**Peebles & District Community Council**  
**Planning Report**  
**Draft Thu 8 October 2026**

**1.0 General**

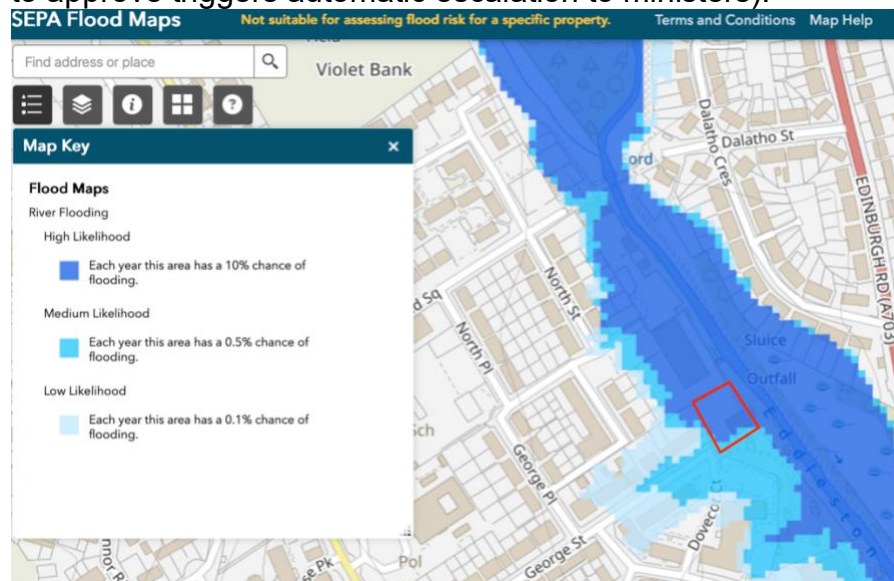
- 2.2 [26/00647/FUL](#) – **Erection of MOT service building – Peebles Autocentre George Street.** Car garage and sales centre.
- 2.2.1 The proposal is on ground currently used by the applicant, an established business, to carry on automotive operations.
- 2.2.2 Very little information is provided with the application.
- 2.2.3 Two objections refer to previous flooding, Eddleston Water and call for Flood Risk Assessment. They also cite traffic, parking and noise.
- 2.2.4 [SEPA Flood maps](#) and SBC confirm the site at  $\geq 10\%$  annual risk of flooding, thus an FRA appears to be required (and recommendation to approve triggers automatic escalation to ministers).

- Contains public sector information licensed under the [Open Government Licence v3.0](#).
- 2.2.5 Applicant's 3-paragraph "Flooding Statement" (on the Plans and Elevations) appears not to have been prepared by a qualified expert (and appears to misunderstand flood risk).

- 2.2.8 20 May 2026 SBC confirm HRA required (via email to PCC).
- 2.2.9 [21 May 2026](#) PCC lodge holding objection (until HRA complete).
- 2.2.10 3 Jul 2026 Flood risk officer cites 0.5% flood risk (later says  $\geq 10\%$ )

- 2.2.11 [7 Jul 2026](#) PCC share map above, call for Flood Risk Assessment.
- 2.3 [26/00518/TCA](#) – **Work to trees – Priorsford House Tweed Avenue.** No recommendation (no information available on portal).
